ADDENDUM

NO. 2

PROJECT NAME: Humble ISD Creekwood and Riverwood Middle School Additions and Renovations

ADDENDUM DATE: Thursday, April 24th, 2025

PACKAGE
Job No.
1821-13-01
Drawn By:
NY
Date:
04.01.2025
VOLUME
Sheet No.
T0.00

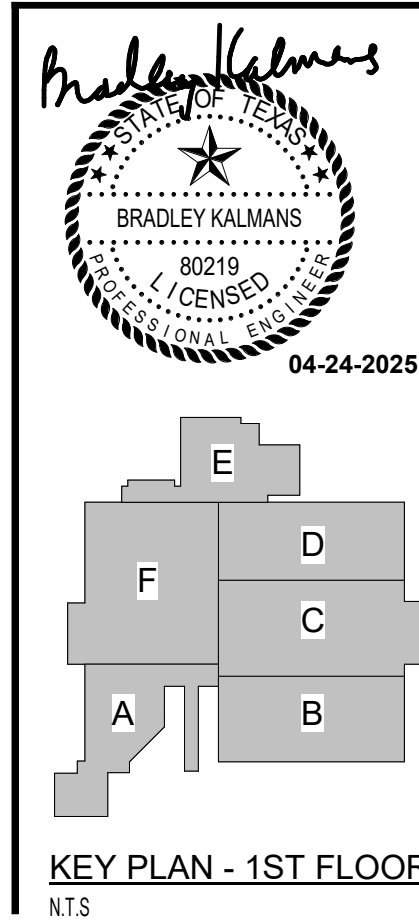
1. T0.00 – TECHNOLOGY NOTES AND LEGENDS
 - a. Revise Video Surveillance Legend Notes and Symbols

VIDEO SURVEILLANCE LEGEND				
SYMBOL	DESCRIPTION	ELEVATION	BACK BOX/RACEWAY	NOTES
W	WALL/CORNER MOUNT 4-SENSOR CAMERA	REFERENCE FLOOR PLANS	4"x4"x2 1/8" BACK BOX WITH 1-G MUD RING, 1" C	NOTE #5, #6
W	CEILING MOUNTED 4-SENSOR CAMERA	CEILING		NOTE #5, #6
W	2-SENSOR CAMERA	REFERENCE FLOOR PLANS	4"x4"x2 1/8" BACK BOX WITH 1-G MUD RING, 1" C	NOTE #5, #6
W	1-SENSOR CAMERA	REFERENCE FLOOR PLANS	4"x4"x2 1/8" BACK BOX WITH 1-G MUD RING, 1" C	NOTE #5, #6
W	SYMBOL INDICATES THAT A VIDEO SURVEILLANCE DEVICE IS WALL MOUNTED			
NOTES: 1. #G INDICATES BACK BOX SIZE. 2. #C INDICATES CONDUIT SIZE. 3. UNO, UNLESS NOTED OTHERWISE. 4. THE SYSTEM INTEGRATOR SHALL COORDINATE ALL BOX AND CONDUIT SIZE REQUIREMENTS PRIOR TO ROUGH-IN BY THE PROJECTS ELECTRICAL CONTRACTOR. 5. PROVIDE AND INSTALL ONE (1) CATEGORY CABLE TO CONNECT DEVICE TO NETWORK. 6. VIDEO SURVEILLANCE CAMERAS ARE OFCI.

Salas O'Brien		PACKAGE	VOLUME
Houston 10930 W. Sam Houston Pkwy North, Suite 900 Houston, TX 77064 Salas O'Brien Registration: F-4111 Salas O'Brien Project Number: 2022-05088-00		Job No. 1821-13-02 Drawn By: NY Date: 04/01/2025	Sheet No. T0.00

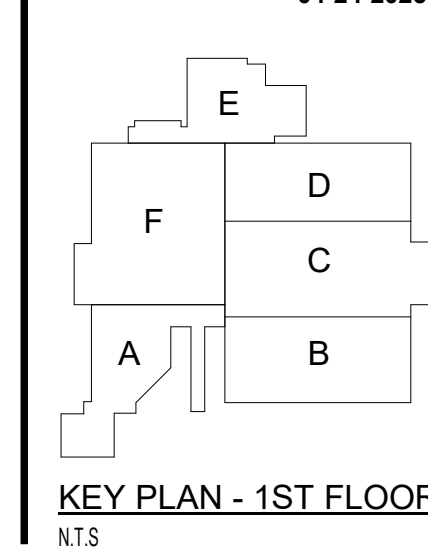
2. T0.00 – TECHNOLOGY NOTES AND LEGENDS
 - a. Revise Video Surveillance Legend Notes and Symbols

VIDEO SURVEILLANCE LEGEND				
SYMBOL	DESCRIPTION	ELEVATION	BACK BOX/RACEWAY	NOTES
[C]	WALL/CORNER MOUNT 4-SENSOR CAMERA	REFERENCE FLOOR PLANS	4"x4"x2 1/8" BACK BOX WITH 1-G MUD RING, 1" C	NOTE #5, #6
[C]	CEILING MOUNTED 4-SENSOR CAMERA	CEILING		NOTE #5, #6
[C]	2-SENSOR CAMERA	REFERENCE FLOOR PLANS	4"x4"x2 1/8" BACK BOX WITH 1-G MUD RING, 1" C	NOTE #5, #6
[C]	1-SENSOR CAMERA	REFERENCE FLOOR PLANS	4"x4"x2 1/8" BACK BOX WITH 1-G MUD RING, 1" C	NOTE #5, #6
[V]	SYMBOL INDICATES THAT A VIDEO SURVEILLANCE DEVICE IS WALL MOUNTED			
NOTES: 1. # - G INDICATES BACK BOX SIZE. 2. # - C INDICATES CONDUIT SIZE. 3. UNO - UNLESS NOTED OTHERWISE. 4. THE SYSTEM INTEGRATOR SHALL COORDINATE ALL BOX AND CONDUIT SIZE REQUIREMENTS PRIOR TO ROUGH-IN BY THE PROJECTS ELECTRICAL CONTRACTOR. 5. PROVIDE AND INSTALL ONE (1) CATEGORY CABLE TO CONNECT DEVICE TO NETWORK. 6. VIDEO SURVEILLANCE CAMERAS ARE OPI.
